TRANS/WP.29/GRE/2003/34  
7 July 2003

PROPOSAL FOR DRAFT AMENDMENTS TO REGULATION No. 98

(Headlamps with gas-discharge light sources)

Transmitted by the expert from the Working Party "Brussels 1952" (GTB)

"Figure D  
Primary Driving Beam

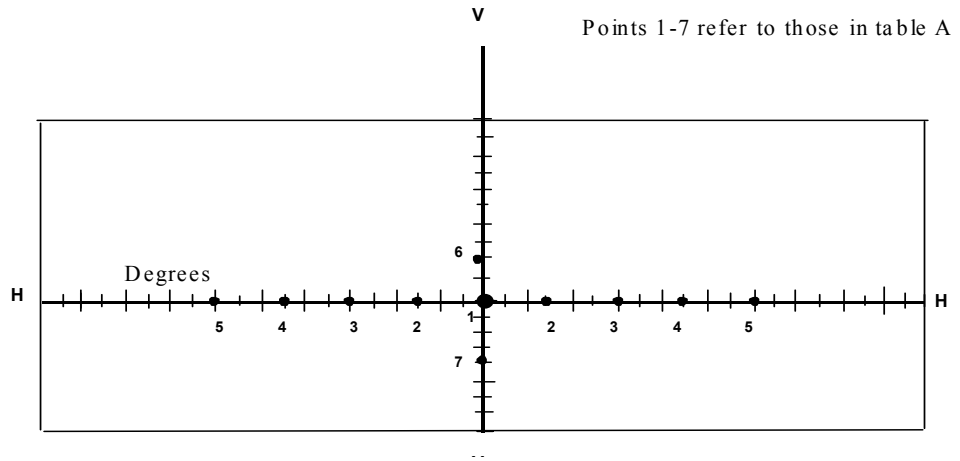
Add at the end of annex 3 figures D and E, to read:

Table A - Primary driving beam headlamp

Refer to Figure D for details of test point positions

TEST POINT NUMBER	TEST POINT LOCATION	Required illumination in lux	
		Min.	Max.
1	H-V (1/)	(1/)	---
2	H-3R & 3L	40.0	---
3	H-6R & 6L	10.0	---
4	H-9R & 9L	4	---
5	H-12R & 12L	1.2	---
6	2U-V	2	---
7	4D-V	---	(2/)
	MAX. LUMINOUS INTENSITY	70.0	180.0

- (1/) Intensity at H-V shall be equal to or greater than 80 per cent of the maximum intensity in the beam pattern.  
 (2/) Intensity at 4D-V shall be equal to or less than 30 per cent of the maximum intensity in the beam pattern.
